# UNITED STATES PATENT AND TRADEMARK OFFICE

APPLICATION NO.	FILING DATE	FIRST NAMED INVENTOR	ATTORNEY DOCKET NO.	CONFIRMATION NO.
10/671,863	09/29/2003	Ju-hwan Kim	1572.1100	5397

# Office Action Summary

This is the **Final Office Action** for application number 10/671,863 Display Apparatus, filed on 9/29/03. Claims 1-39 are pending. This **Final Office Action** is in response to applicant's reply dated 5/24/05. The text of those sections of Title 35, U.S. Code not included in this action can be found in a prior Office action.

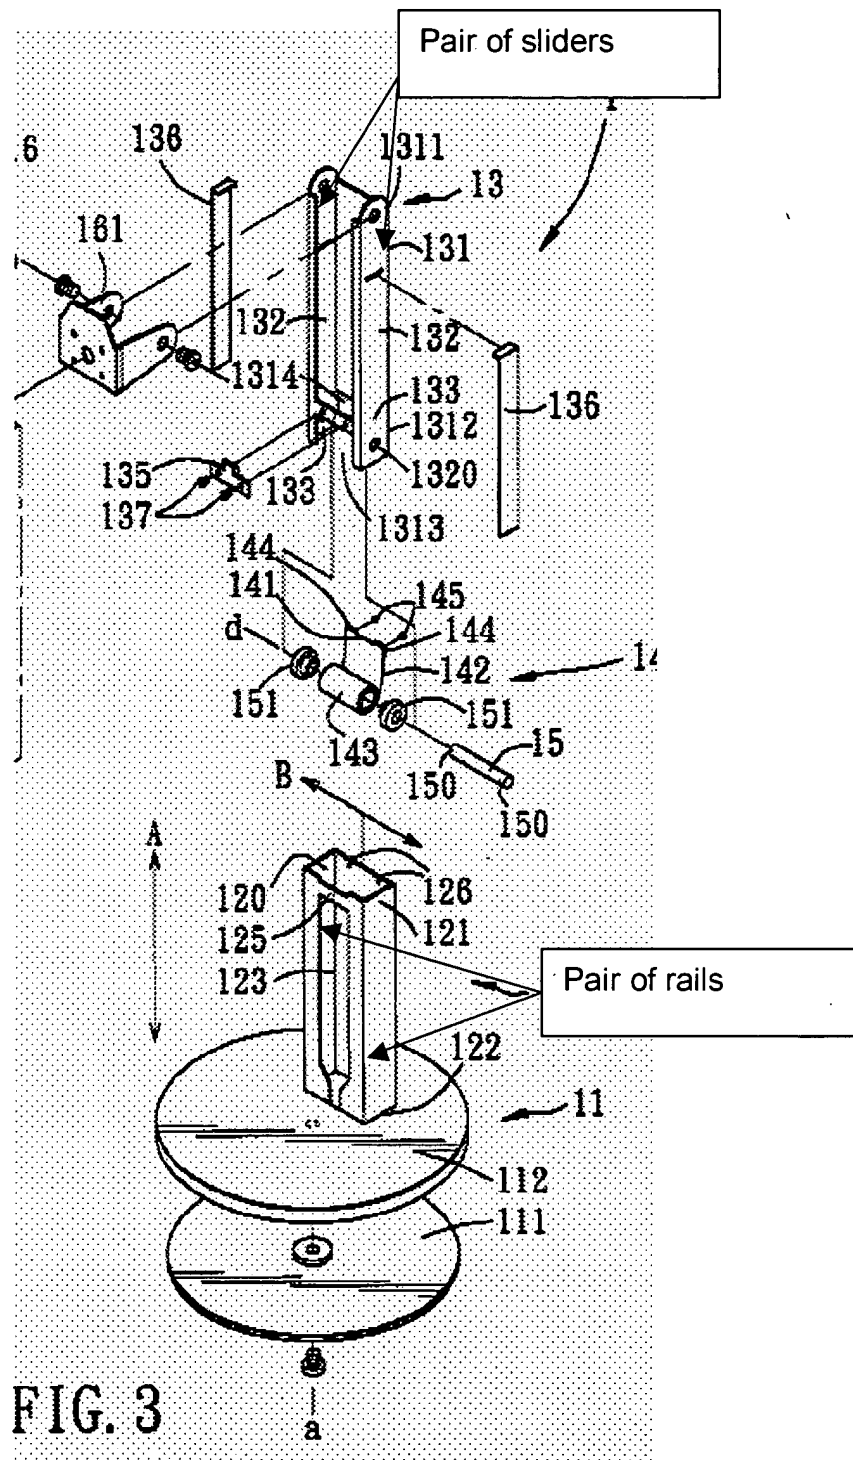
Claims 1-4, 30 and 38 are rejected under 35 U.S.C. 102(b) as being anticipated by United States Patent No. 6712321 to Su et al.

The patent to Su et al discloses a display apparatus having a base part (111), a monitor body (2) a body bracket (162) fixedly coupled to the monitor body (2), a pair of sliders (1311, See Drawing Below) adjustable fasteners (C) connected to the monitor body (16) to be engaged with a pair of parallel guide rails (121, See Drawing Below) to stand on the base part, and a guide bracket (136) coupled to the guide rails and a stand supporting part (112) installed on the base part and a connecting assembly (b) to connect the stand part to the body bracket, and a supporting bracket (161) to support the connecting assembly. Sue et al also teaches at least one spiral spring (143) having an elasticity enough to support weight of the main body to extend and contract in response to the movement of the slider. Su et al. also shows a spring supporting block (135) provided between the sliders wherein the at least one spiral spring (143) has a
